Economic Commission for Europe**Inland Transport Committee****World Forum for Harmonization of Vehicle Regulations****Working Party on Automated/Autonomous and Connected Vehicles****Seventh session**

Advanced Emergency Braking Systems**Proposal for Supplement 2 to the 01 series amendment text to
UN Regulation No. 152 (Advanced Emergency Braking
Systems for M₁ and N₁ vehicles)****Submitted by the experts from the Informal Working Group on
Advanced Emergency Braking Systems for vehicles of Categories M₁
and N₁***

Figure 1: left turn or right turn at the intersection

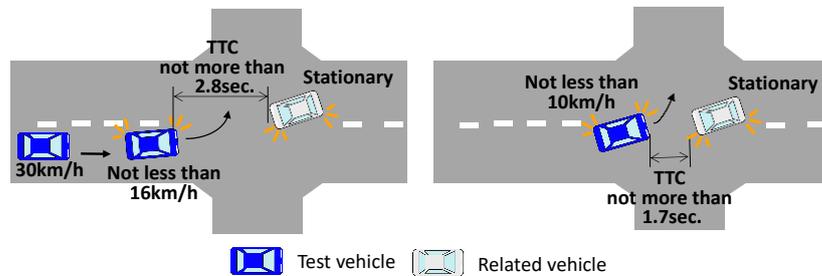
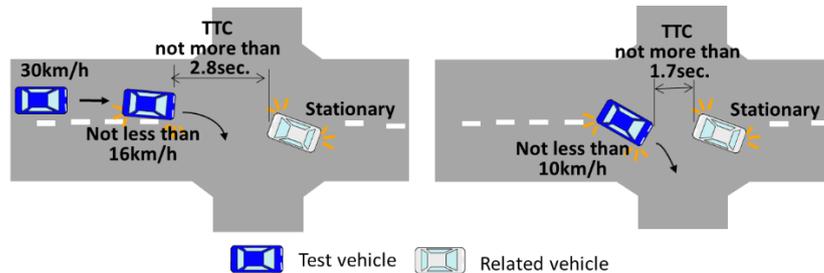
Insert new Scenarios 1 to 4, to read:

Left turn or Right turn at the intersection

1.1. In this scenario, the subject vehicle passes by a left turn or right turn in front of an oncoming vehicle that is stopped to make a left turn or right turn at an intersection.

The subject vehicle drives at a speed of 30 km/h (with a tolerance of +0/-2 km/h) toward the intersection, and decelerates by braking to a speed of not less than 16 km/h at a point where the subject vehicle begins to steer left / right, and the Time To Collision (TTC) to the oncoming vehicle is not more than 2.8 seconds. When the subject vehicle turns left or right in the intersection, the speed is reduced to not less than 10 km/h, and then drives at a constant speed. The TTC to the oncoming vehicle is not more than 1.7 seconds at when the wrap ratio between the subject vehicle and the oncoming vehicle becomes 0 per cent.

Figure 2: right turn or left turn of a forward vehicle

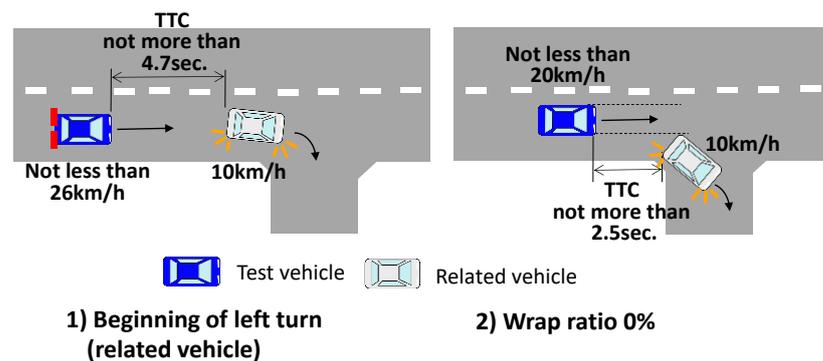
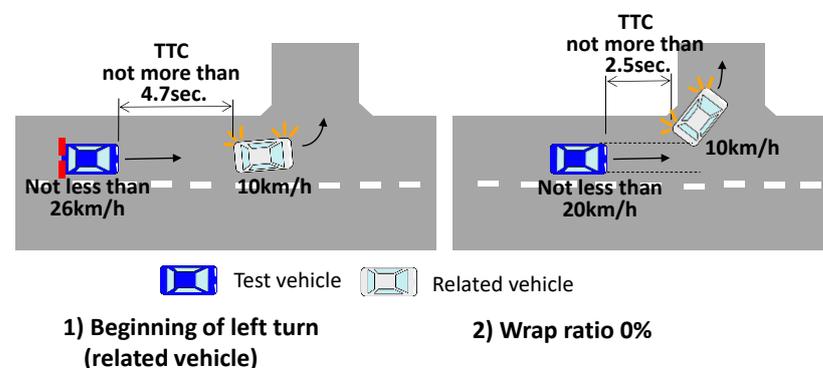
Right turn or Left turn of a forward vehicle

2.1. In this scenario, the subject vehicle follows a forward vehicle. After that, the forward vehicle turns right or left at a corner, and the subject vehicle goes straight.

Both the forward vehicle and the subject vehicle drive at a speed of 40 km/h (with a tolerance of ± 2 km/h) on the straight road. The forward vehicle decelerates by braking to a speed of 10 km/h (with a tolerance of ± 2 km/h) in order to turn right or left at the corner, and the subject vehicle also decelerates by braking to keep appropriate distance with the forward vehicle. At when the forward vehicle begins to turn right or left, the speed of the subject vehicle is not less than 26 km/h and the TTC to the frontal vehicle is not more than 4.7 seconds. After that, the subject vehicle decelerates to a speed of not less than 20 km/h, and then drives at a constant speed. The TTC to the forward vehicle is not more than 2.5 seconds at when the wrap ratio between the subject vehicle and the forward vehicle becomes 0 per cent.

Figure 3: curved road with guard pipes and a stationary object

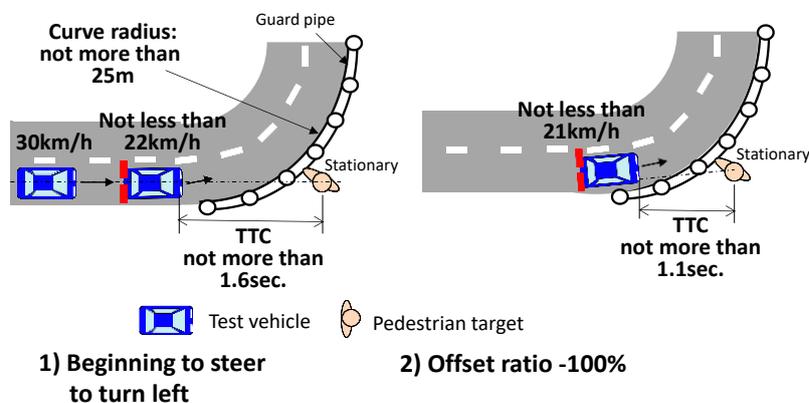
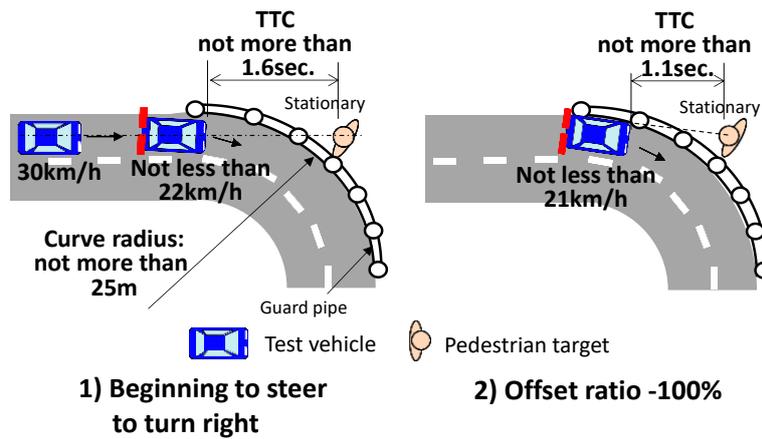
Curved road with guard pipes and a stationary object

3.1. In this scenario, the subject vehicle drives a small radius curved road of which the guard pipes are constructed to the outer side, and a stationary vehicle (M₁ category), a stationary pedestrian target or a stationary bicycle target is positioned just outside of the guard pipes and where on the extension of the centre of the lane.

The subject vehicle drives at a speed of 30 (with a tolerance of +/-2 km/h) km/h toward the curve of which the radius is not more than 25 m at the outer side of the road, and decelerates by braking to a speed of not less than 22 km/h at a point where the subject vehicle enters the curve. The TTC to the stationary object is not more than 1.6 seconds at when the subject vehicle begins to turn in the curve. In the curve, the subject vehicle drives outer lane than the centre of the road. After that, the subject vehicle continue to turn in the curve at a constant speed of not less than 21 km/h. The TTC to the stationary object is not more than 1.1 second at when the wrap ratio between the subject vehicle and the stationary vehicle becomes 0%, or at when the offset ratio between the subject vehicle and the centre of the stationary pedestrian target or the stationary bicycle target becomes -100%.

Figure 4: lane change due to road construction

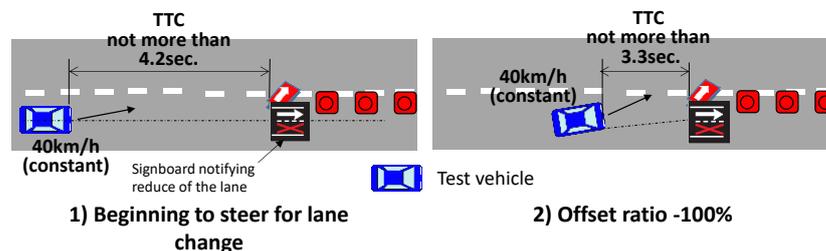
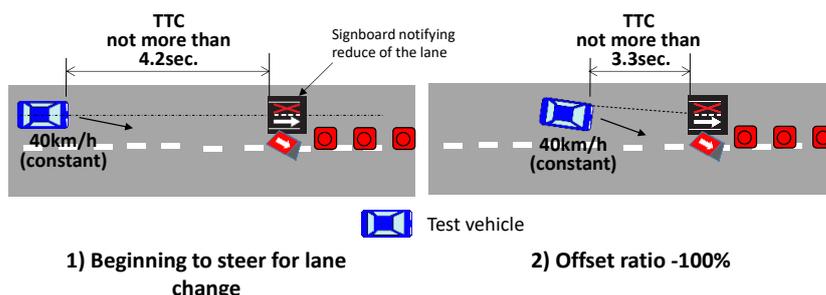
Lane change due to road construction

- 4.1. In this scenario, the subject vehicle changes the lane in front of the signboard which is positioned in the centre of the lane and notifies the driver that the lane is reduced.
- 4.2. An example of the detail scenario:
 The subject vehicle drives a straight road at a speed of 40 km/h (with a tolerance of +0/-2 km/h), and begins to steer in order to change the lane in front of the signboard which notifies reducing the lane. No other vehicles approach the subject vehicle. The TTC to the signboard is not more than 4.2 seconds at when the subject vehicle begins to steer. During changing the lane, the speed of the subject vehicle is constant, and the TTC to the signboard is not more than 3.3 seconds at when the offset ratio between the subject vehicle and the centre of the signboard becomes -100%.
